PSEG Public Service
Electric and Gas
Company

HOPE CREEK GENERATING STATION
DOCKET NO. 50-354
NRC REVIEW OF STRUCTURAL/GEOTECHNICAL TOPICS

Attachment: Resolution of NRC Comments on
Structural/Geotechnical Topics

FIGURE 1
 IDEALIZED FREE-FIELD SOIL COLUMN FOR DECONVOLUTION
 (POWER BLOCK AREA NORTH-SOUTH DIRECTION)

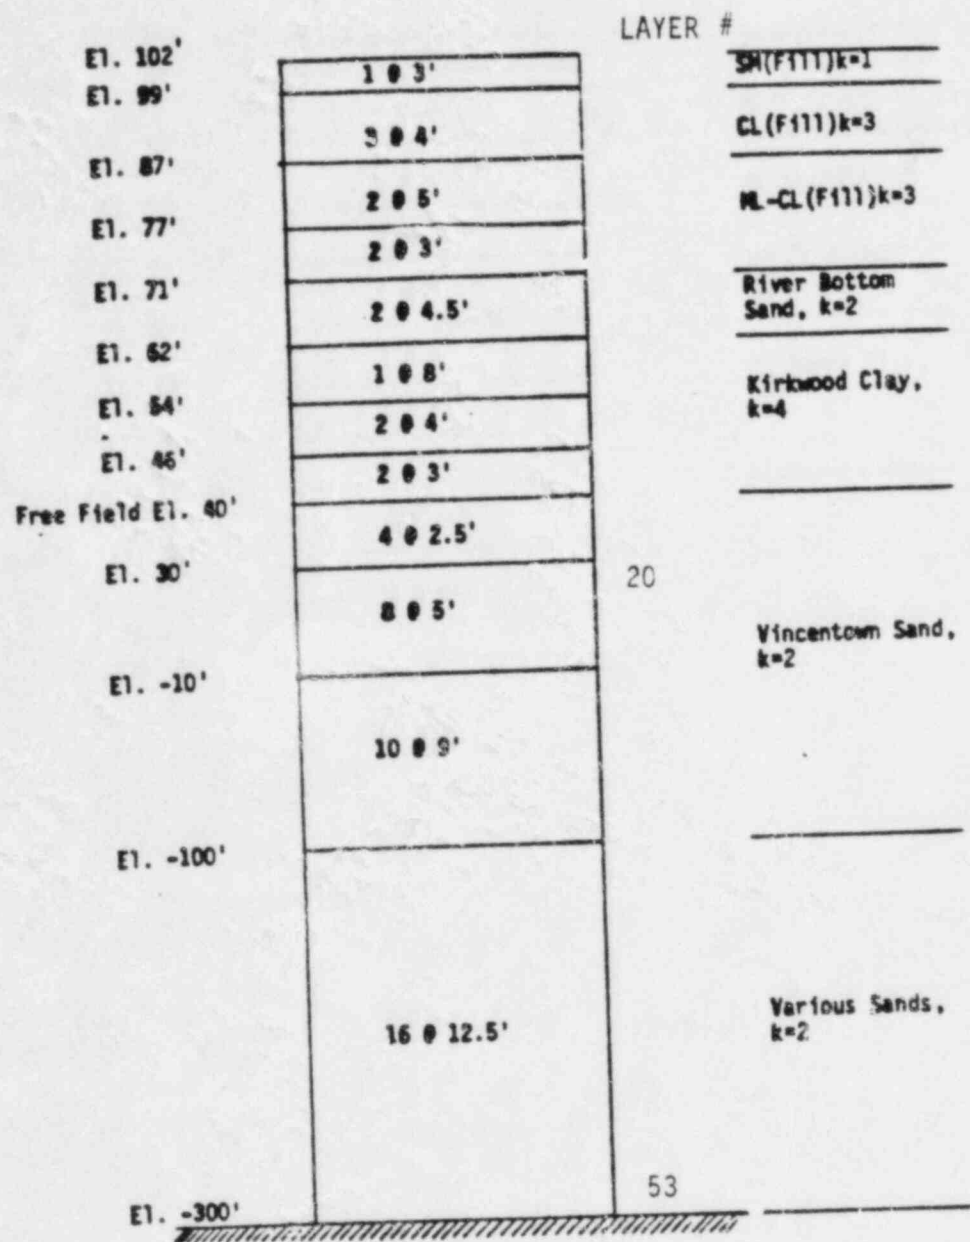
QUESTION: Provide tabulations of shear moduli used for:

- . soil column model
- . design basis model

RESPONSE: The attached Figure 1 shows a typical soil column used for the deconvolution analysis.

The attached Table 1 shows a comparison of the final iterated shear moduli used in the deconvolution analysis (which corresponds to free-field conditions) and the final iterated shear moduli used in the SSI analysis. The column of soil from which the SSI values have been extracted corresponds to a location underneath the reactor building, as indicated in Figure 2.

Note that the data provided corresponds to layers 20 to 53 in the soil column's model. The corresponding element numbers at similar depths underneath the reactor building are elements numbers 804 to 837.

FIGURE 1: REACTOR BUILDING MATHEMATICAL MODEL

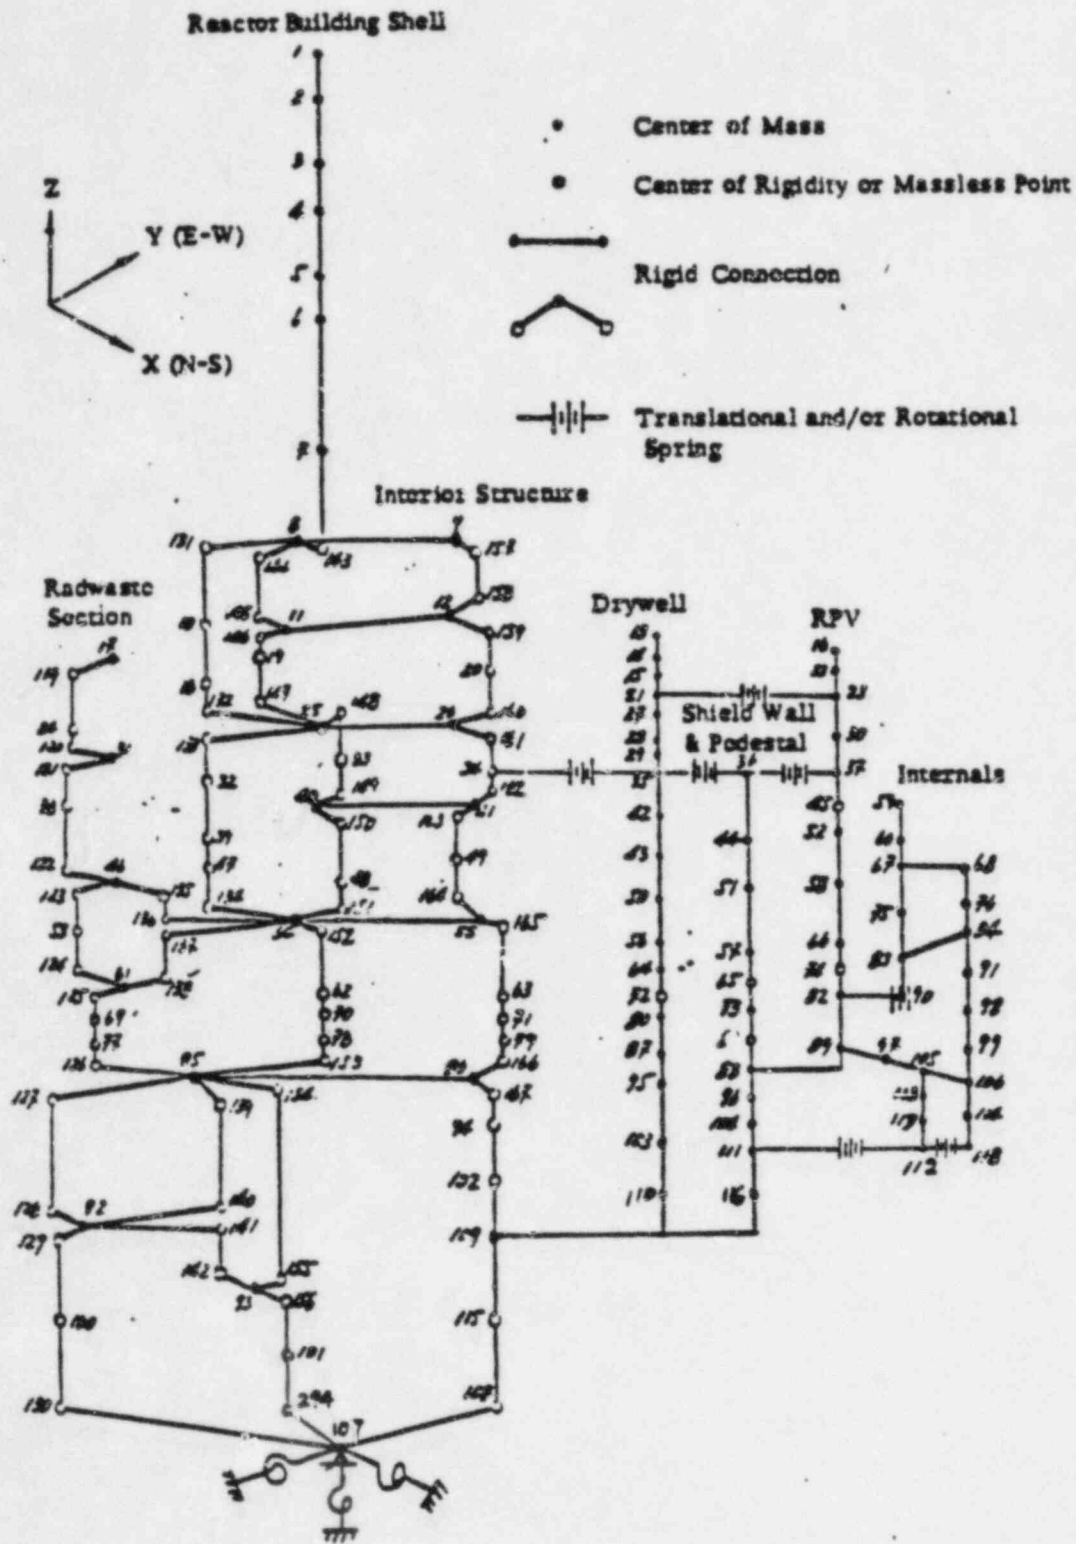
QUESTION: Provide calculation showing how torsional stiffness was established for the reactor building.

RESPONSE: A typical calculation of evaluating torsional stiffness is provided in the attachment. This calculation is performed for beam element between nodes 101 and 294 of Figure 1.

The procedure consists of assigning a number to each wall contributing to the torsional stiffness of the system. (This is shown in Figure 2). For each wall, axial and shear areas are computed. The total shear area in a given direction is computed by adding the contribution of each individual wall in that particular direction. The contribution of the perpendicular walls is neglected. For example, in determining the total shear area in the Y-direction, wall 2 will contribute but wall 13 will not be considered. For special cases such as wall 1 (circular section), half of the area is contributed to each direction. The procedure for arriving at the total torsional stiffness at the location of interest is shown in the tables attached.

FIGURE B-225

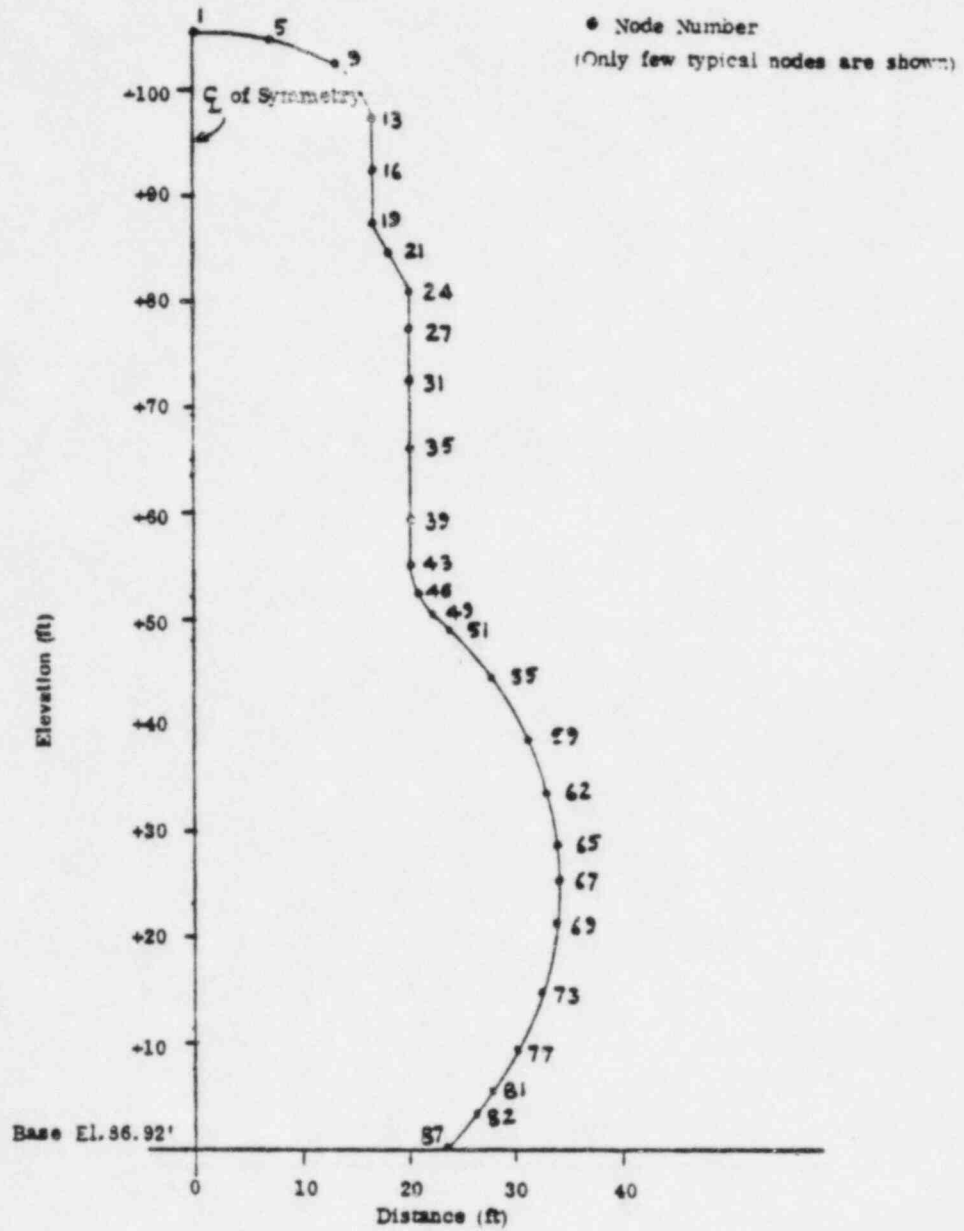
QUESTION: Provide calculations showing drywell stick model development (provide for one section only).

Initially, a unit static shear was applied at the shear lug location of the axisymmetric shell model (Figure B-225). As can be seen from Figure B-226, the results showed that large longitudinal moments and circumferential forces occurred at those critical areas having abrupt change in geometric shape. An "equivalent" beam model was then constructed to match the static deflection of the shear model. This model had two (2) flexible short segments at the base of the Drywell and at the intersection of the cylindrical shell portion and the spherical shell portion (Figure B-227). As a result of these flexible segments, the model is much more flexible than the "classical" beam model.

FIGURE 1

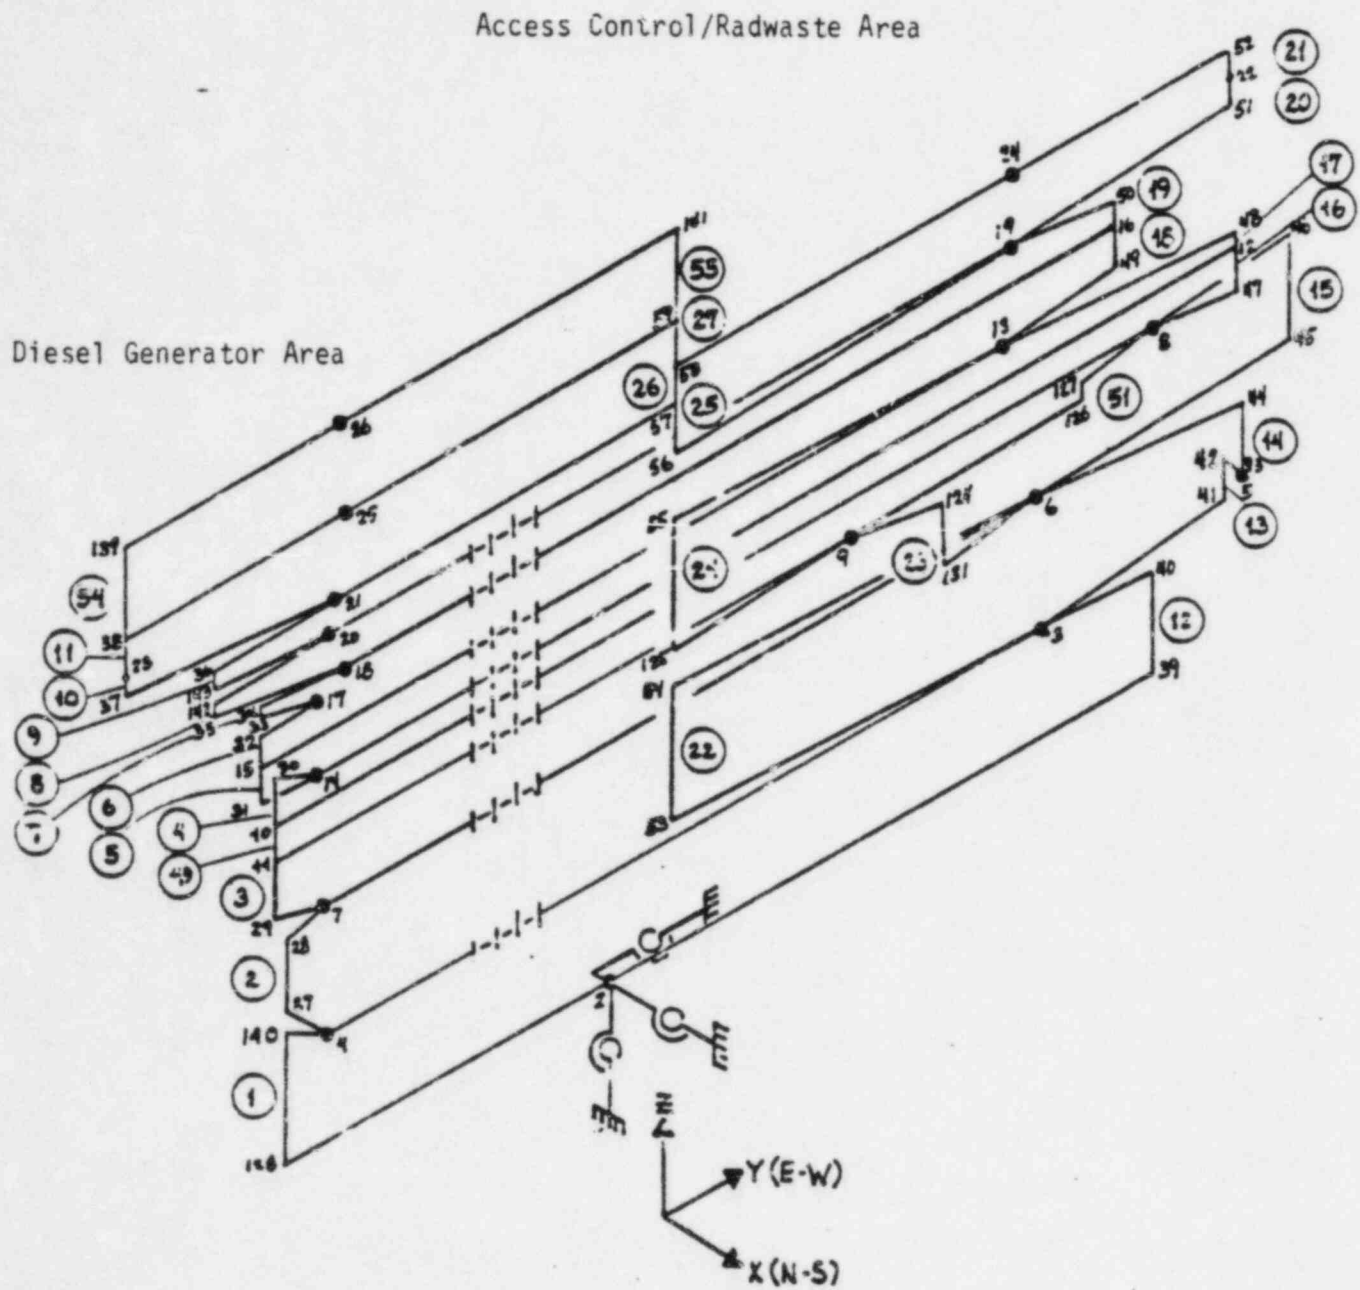
QUESTION: Define location of (x, y, z) "0" reference points for auxiliary building model.

RESPONSE: The attached Figure 1 shows the auxiliary building mathematical model. The auxiliary building plan at the ground elevation (elevation 54.0 ft) is shown in Figure 2.

- a. The center of rigidity for the Control/Radwaste area has x,y,z coordinate (in ft.) of (0.84, 114.09, 54.0). This joint corresponds to nodal point 39 in Figure 1.
- b. The center of rigidity of the Diesel Generator area has x,y,z coordinates (in ft.) of (0.0, -89.70, 54.0). This point corresponds to nodal point 128 in Figure 1.
- c. The center of mass of the complete plan system of walls has x,y,z coordinates (in ft.) of (0.0, -13.00, 54.0). This point corresponds to nodal point 2 in Figure 1. This is the node at which the translational and rotational motions are input to the building model.

SKETCH B.1-1

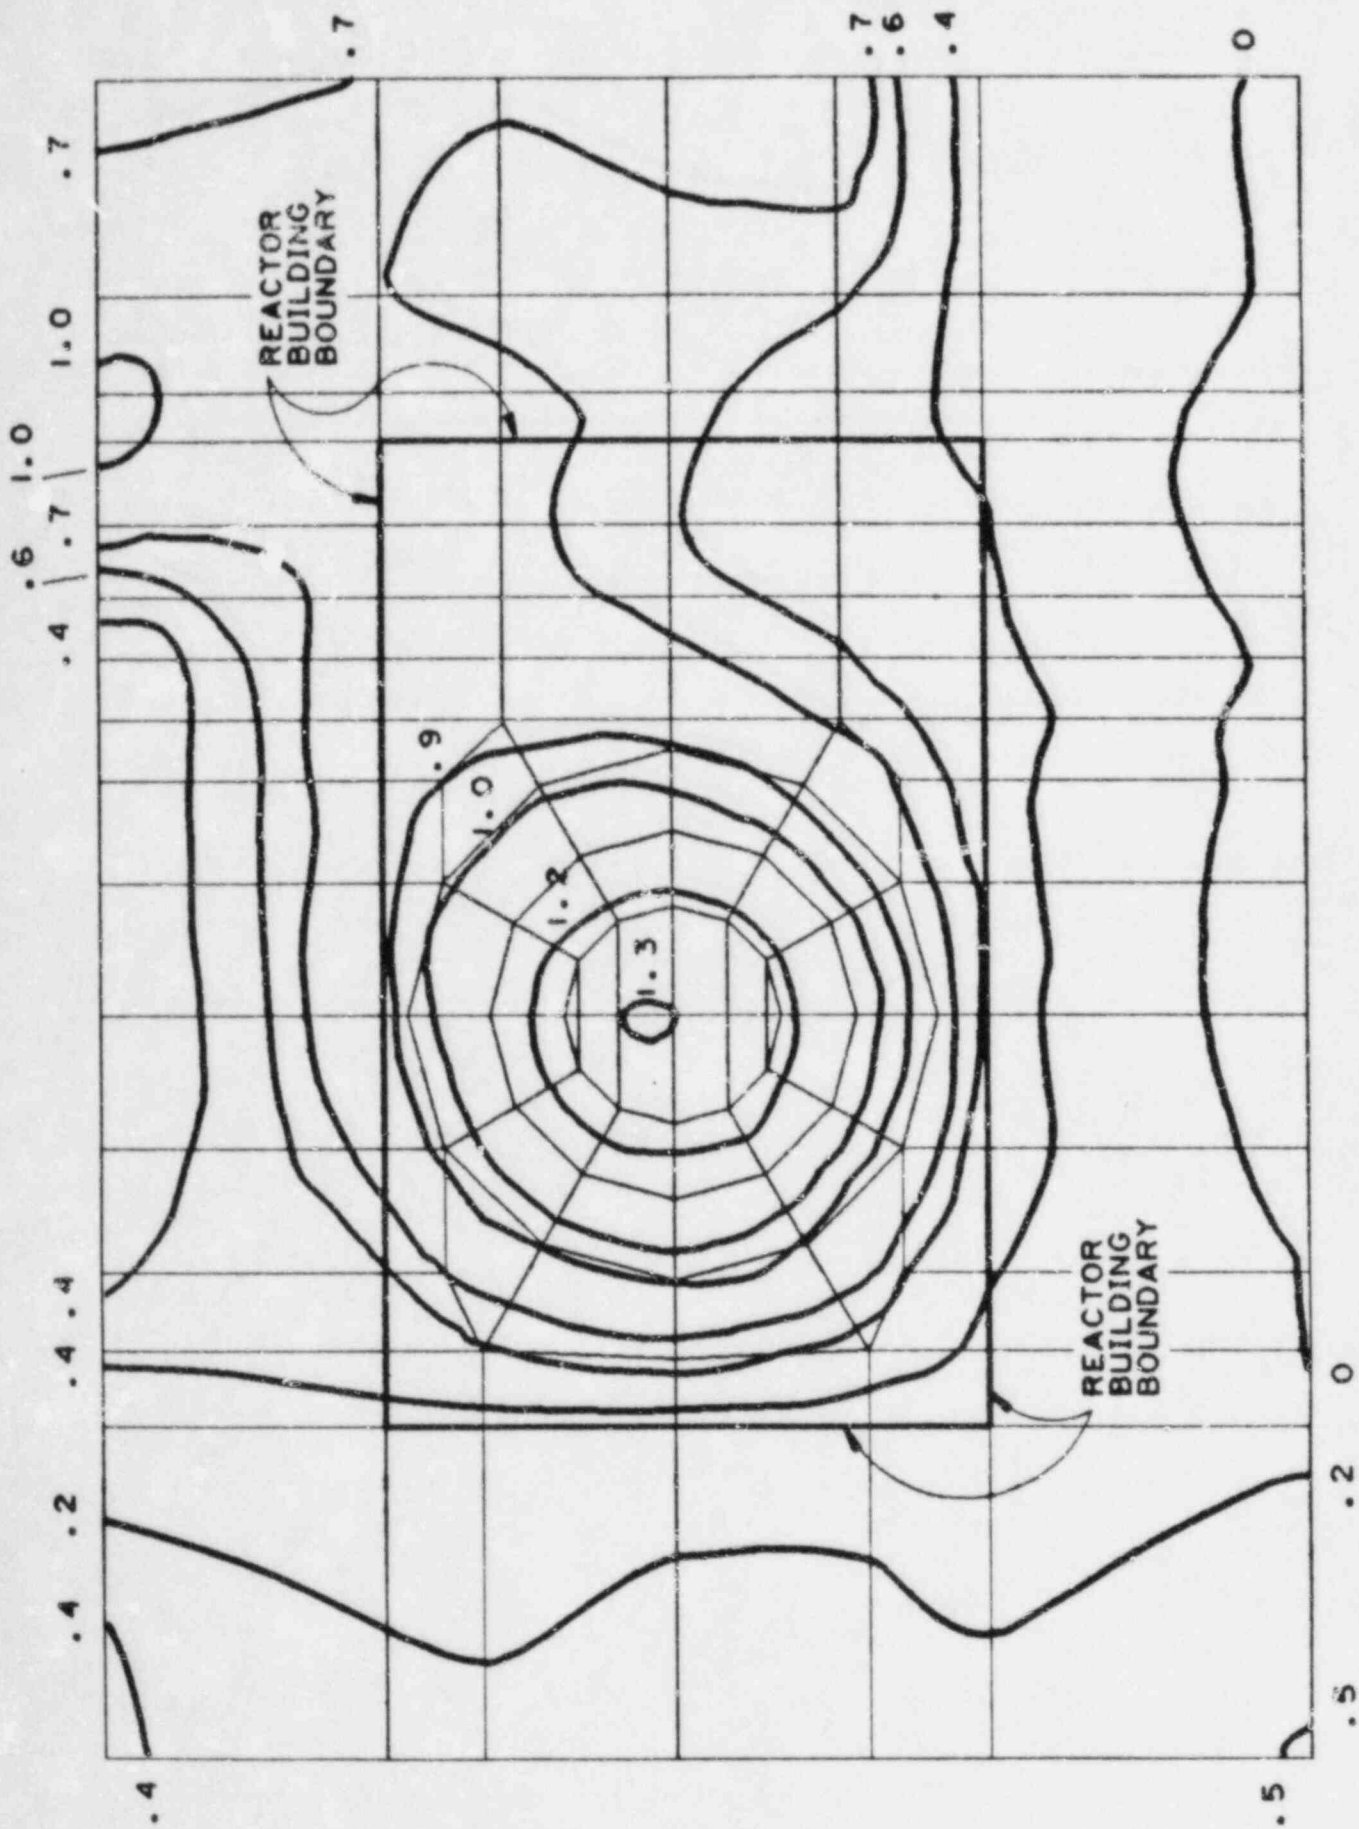
QUESTION: Provide the deflected shape and the soil contact pressures for the reactor building foundation mat (if contact pressures are non-uniform).

RESPONSE: As indicated in FSAR Appendix 3D, Load Combination $1.4D + 1.7L + 1.0F_1$ (F_1 is load due to post-accident containment flooding) governs the flexural reinforcing requirements for the reactor building basemat. This load combination also governs the maximum deflected shape of the reactor building foundation. As shown in Sketch B.1-1, the maximum deflection occurs under the drywell pedestal and radiates outward in an expected dish shape pattern.
